REDTAIL RANCH FILING NO. 1

CONSTRUCTION DRAWINGS

OCTOBER 2018

PCD No. SF-18-021

60' R.O.W. WARD LANE GRAVEL ROAD CROSS SECTION

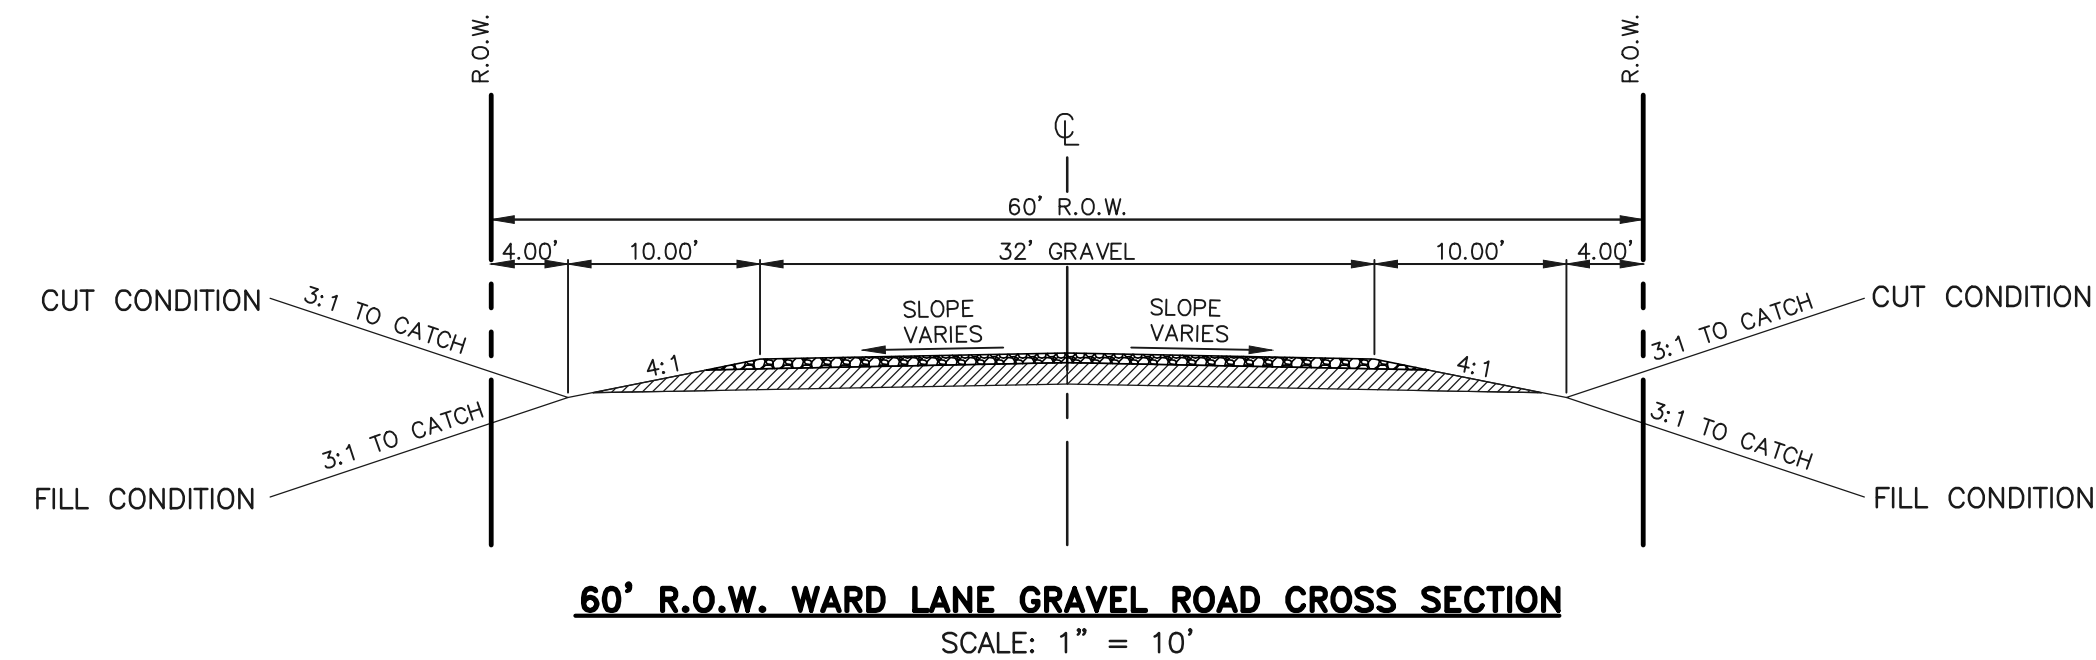
Verify easement location on plat.

ULTIMATE VOLLMER ROAD CROSS SECTION

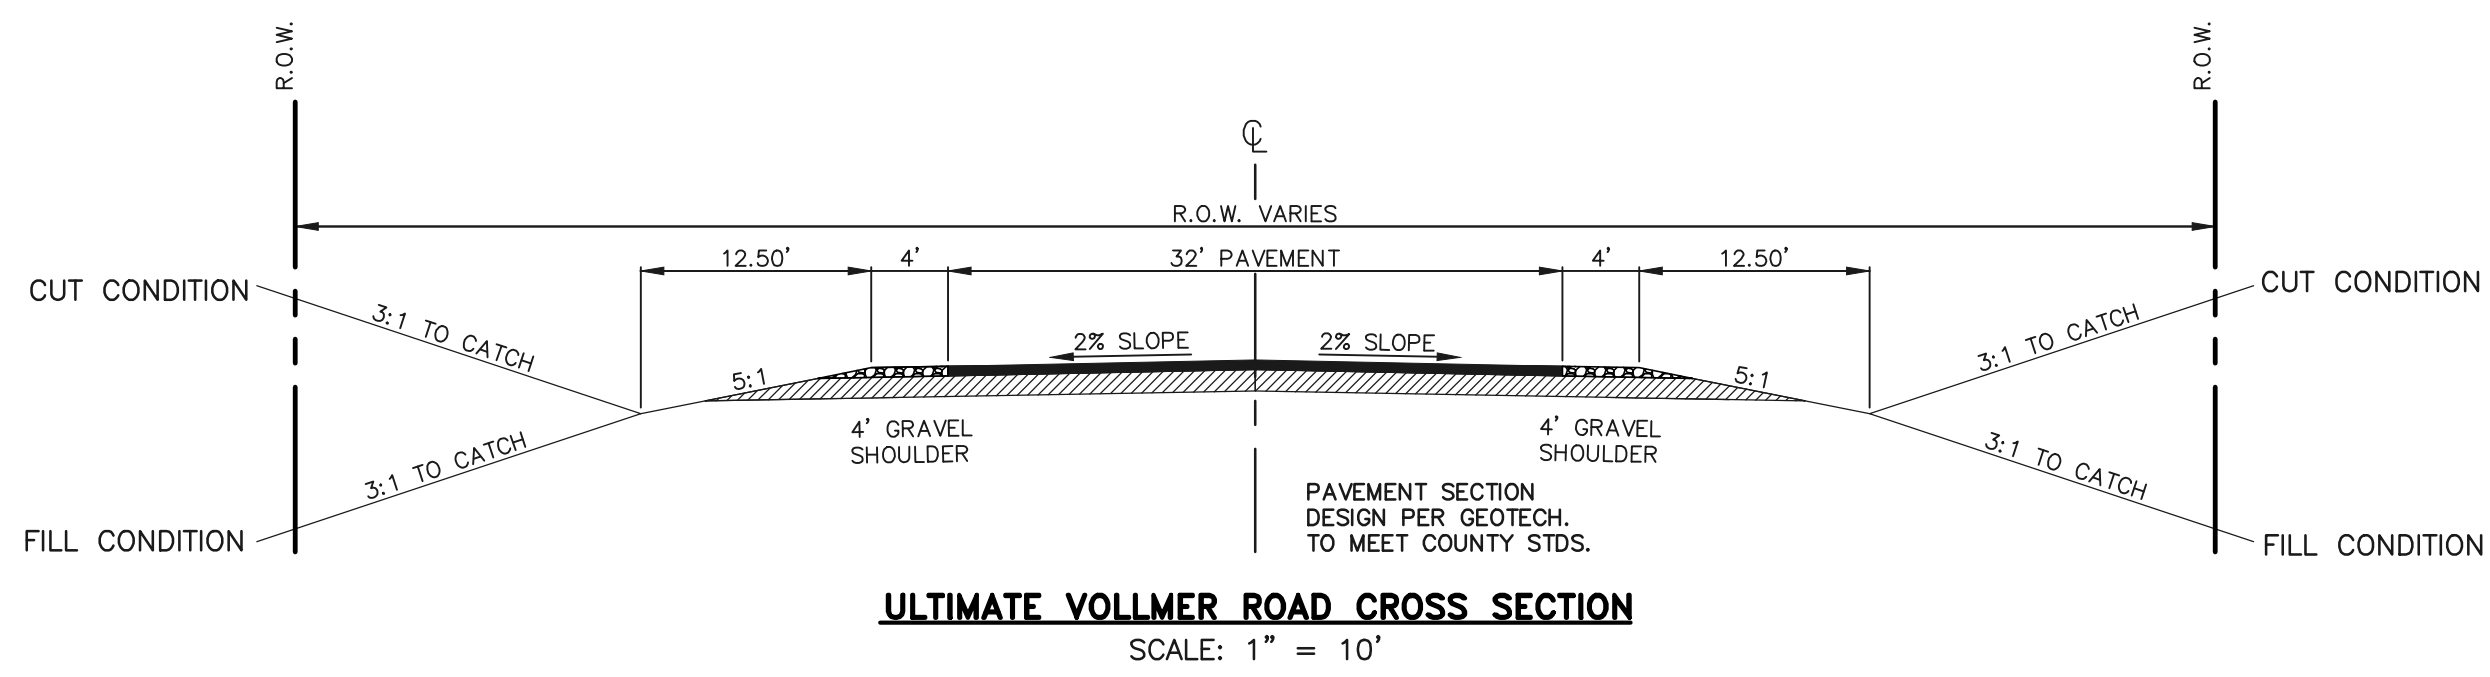
EXISTING WARD LANE CONNECTION TO PROPOSED WARD LANE CONSTRUCTED WITH REDTAIL RANCH FILING NO. 1 DEVELOPMENT
Provide stations. (~10+06 to ~xx+xx) (As shown on grading plans this cross-section is not met.)

SANCTUARY PINE DRIVE
(60' R.O.W. - RURAL LOCAL)
DESIGN SPEED 30 MPH

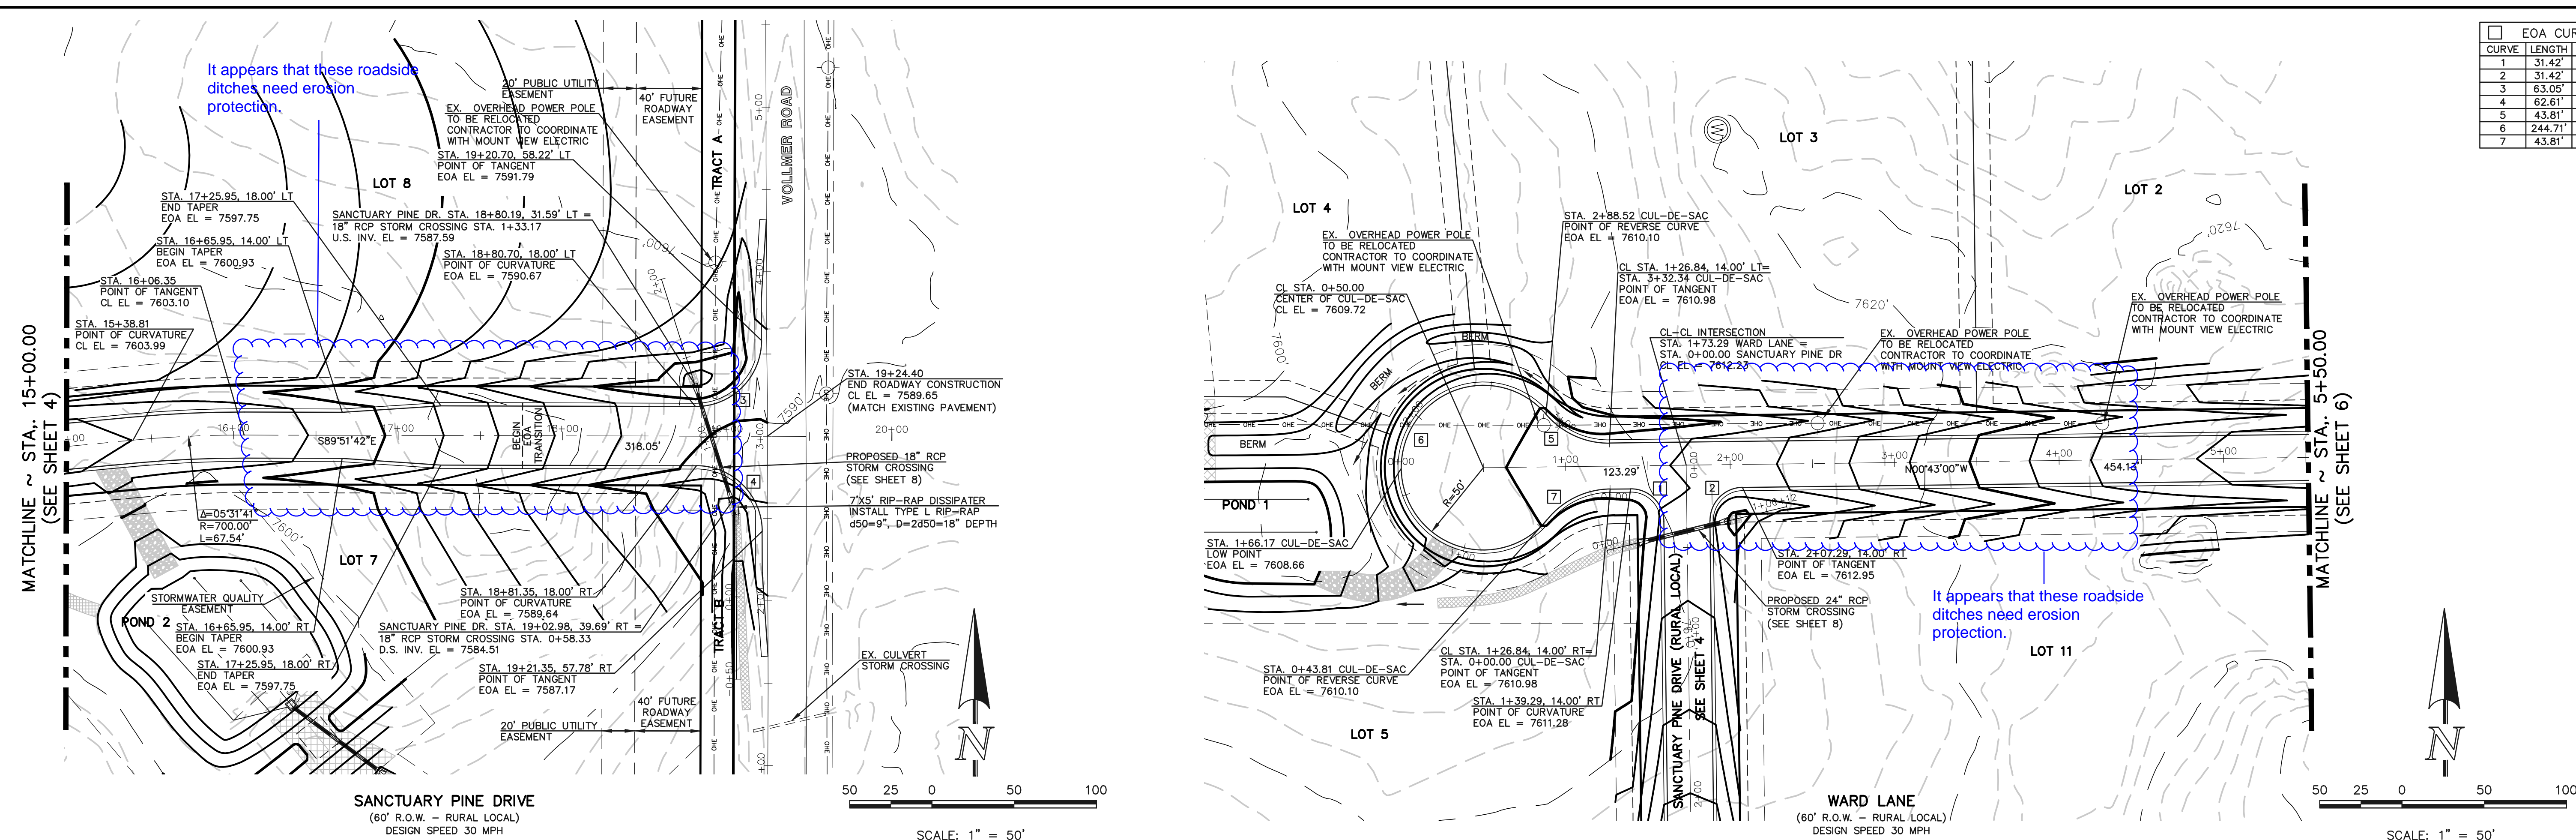
It appears that these roadside ditches need erosion protection.

It appears that these roadside ditches need erosion protection.

NOTE:
 ALL INTERNAL SIGNS SHALL BE
 4" FONT LETTER SIZE.

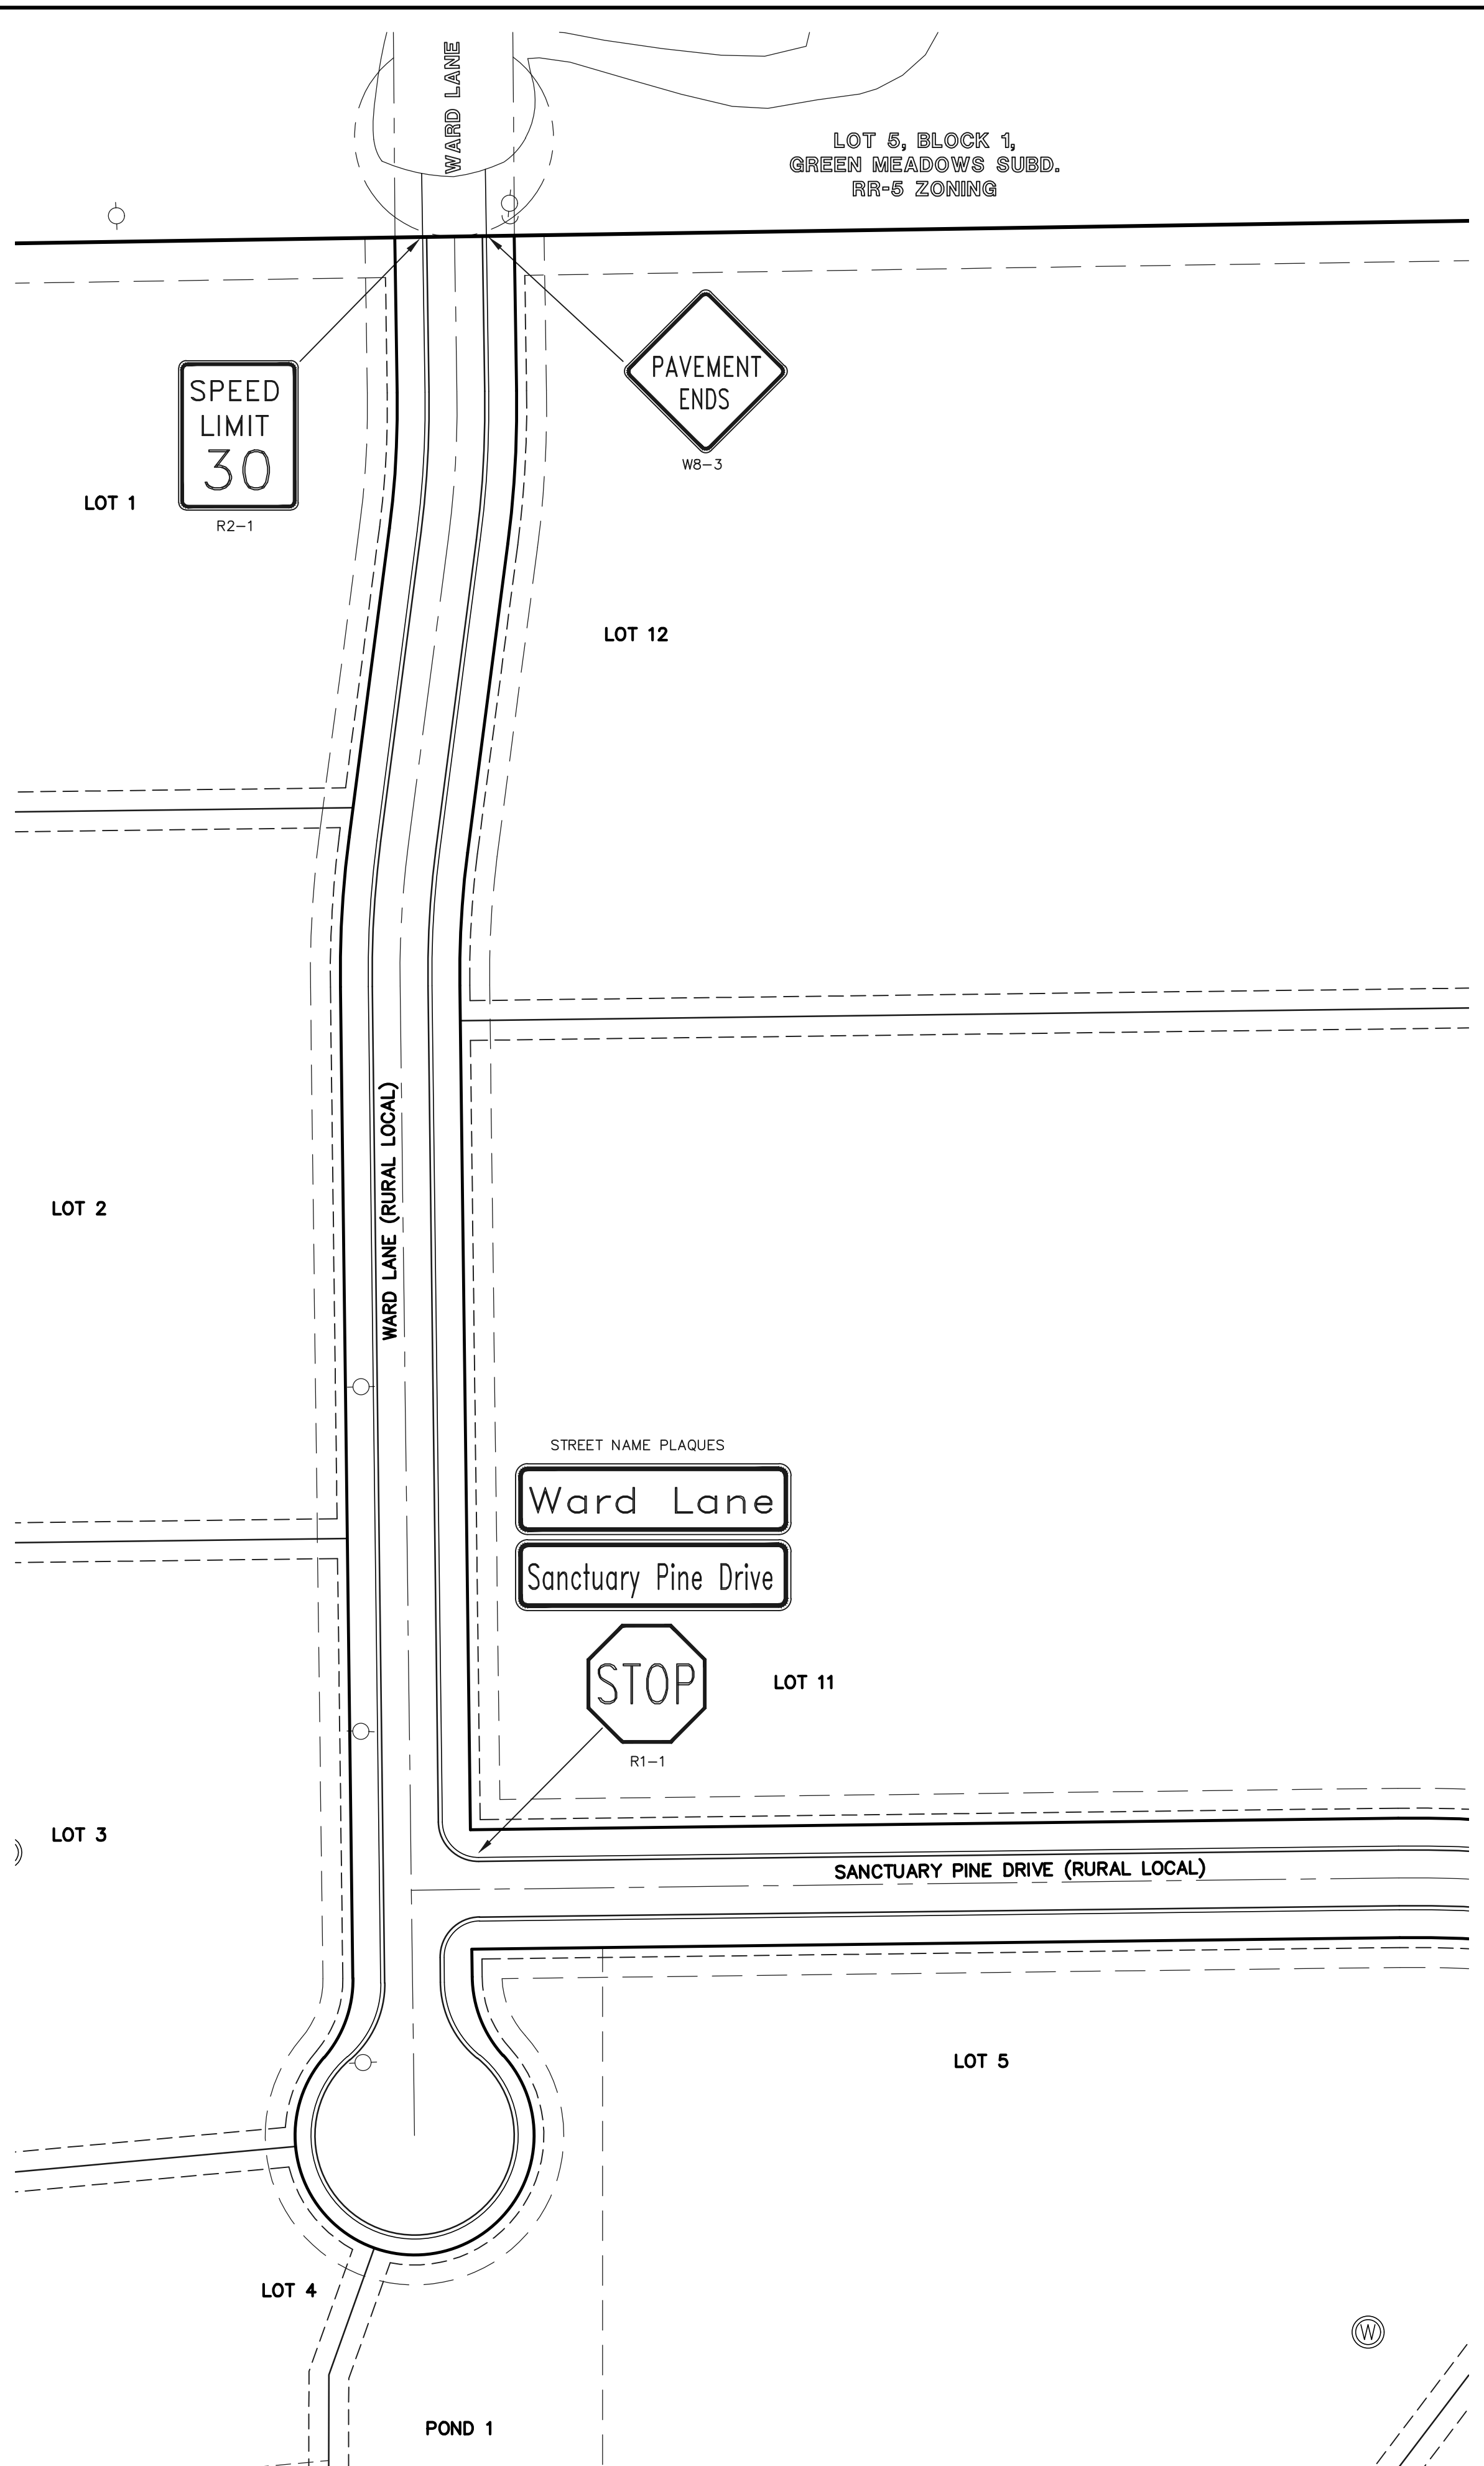
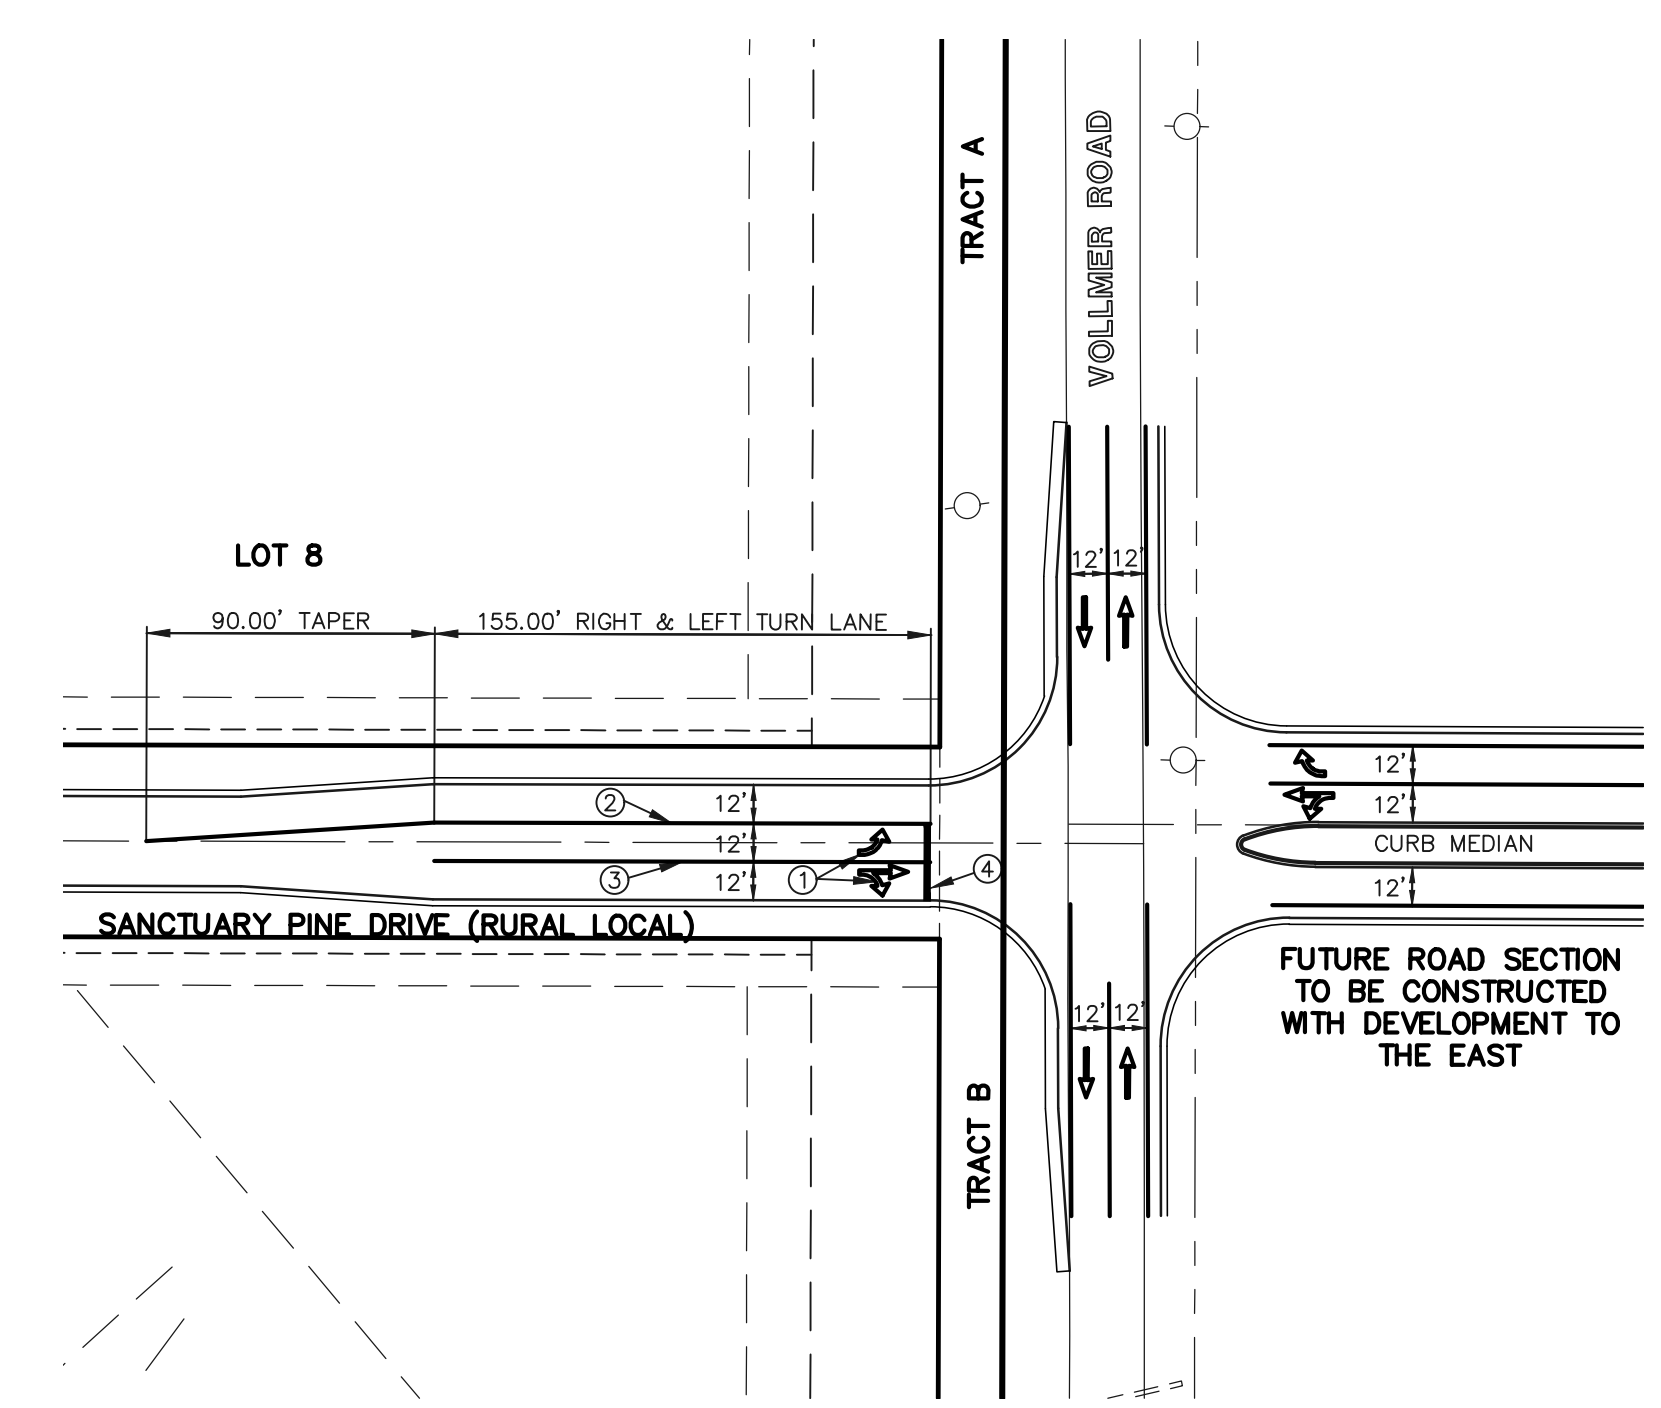
6" on Vollmer?
